## PLAN COMMISSION AGENDA

Tuesday, March 23, 2021  
5:30PM

Conditional Use Permit – County N Storage

Should the Plan Commission recommend approval of a Conditional Use Permit for a proposed mini warehousing development?

# STH 10/CTH N Mini Storage

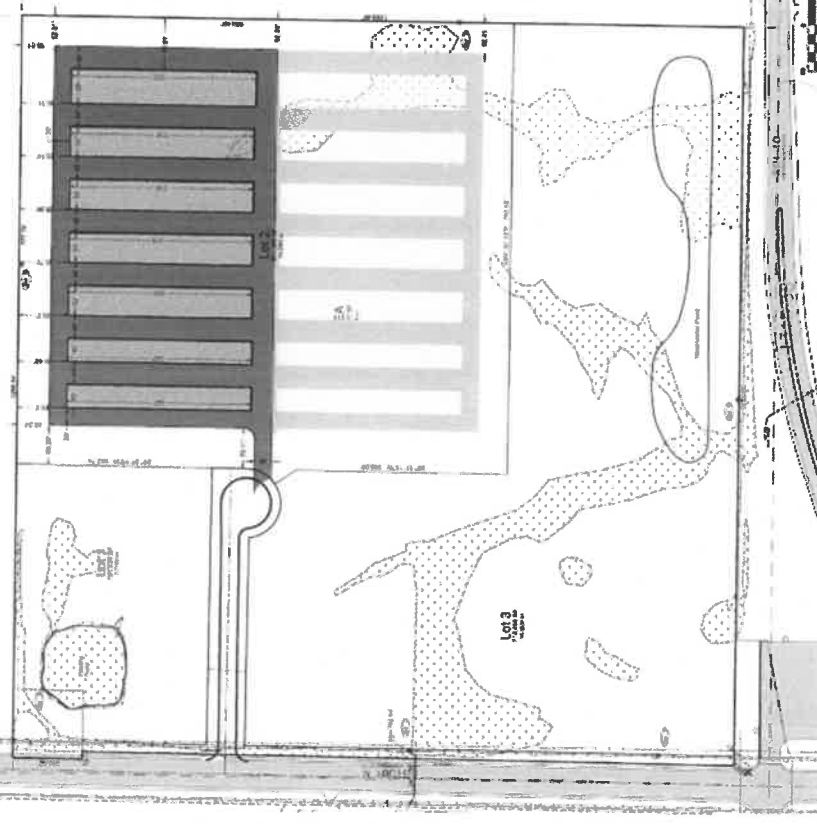
Staff feels that mini-warehousing is not the highest and best use of the property. This property, along with a larger area from County N to State Park Road from Hwy 10 to Manitowoc Road, is identified as future industrial in the Comprehensive Plan Future Land Use Map. The intent of this area was to develop a business or industrial park. Without a major effort to assemble the land and develop an industrial park, a piecemeal approach will make it difficult to plan for future services (e.g. sewer/water, roads, stormwater, etc.). The desire to preserve the area for a planned industrial park is countered by the Comprehensive Plan identifying this area as future industrial with a rezoning application to industrial for this development planned. A rezone to Industrial & Manufacturing [IM] is consistent with the Comprehensive Plan future land use map and mini-warehousing is a conditional use in the IM zoning district.

3. *Traffic. Adequate measures have been or will be taken to provide ingress and egress so designed as to minimize traffic congestion in the public streets. The main entrance is to be a new road off of County Road N. It is anticipated that there will be minimal traffic entering/exiting the development on a daily basis.*

4. *Landscaping and screening. Appropriate landscaping and screening has been or will be provided to protect adjacent uses or properties from light, noise and other visual impacts that are associated with the proposed use as established in article VI, Access, Parking, and Loading and article IX, Landscaping and Screening Standards. Landscaping may be required to meet buffering requirements. Landscape buffer berms around the property may be warranted.*

6. *Services. Adequate facilities, access roads, drainage and/or necessary services have been or will be provided. Sanitary sewer and water can be provided to the site in the future, although the mini-warehousing does not need these facilities. Stormwater management*

will be needed to service the development. A new road access permit will be needed from the Calumet County Highway Department.

1. The proposed Lot 2 property is to be rezoned to the Industrial and Manufacturing [IM] zoning district.
2. Berms and landscape areas be provided along all sides of the development of proposed Lot 2 (mini-warehousing development). The berm should be 5-feet in height with trees, evergreens, and other plantings that are 5-feet in height at the time of planting (not including root ball). Care should be taken to design the berm and plantings to provide approximately 75% opacity within 5-years.

3. Security lighting and video surveillance shall be provided. Any lighting shall be direct cutoff fixtures.
4. The entrance shall be gated with a visually pleasing material, wood or vinyl material. The Plan Commission may approve an alternate material.

5. A new road shall be permitted by the Calumet County Highway Department for access to the development. A street light shall be installed at the developers expense at the intersection of County Road N and the new road. Such street light shall be approved by the Village.

6. No outside storage of any vehicles, equipment, materials, or items shall be permitted.
7. The stormwater management plan approval shall be in accordance with the Harrison rules.

12. Proposed Lot 1 & Lot 3 shall be held for future business/commercial development other than mini warehousing.
13. All WDNR permits shall be granted, a copy of which submitted to the Village, for wetland impacts.

14. The developer shall consult with the Darboy Sanitary District to determine a layout for future sanitary and water access to Lot 1 and Lot 3. Such plan shall be submitted to the Village prior to any building or zoning permit being issued.
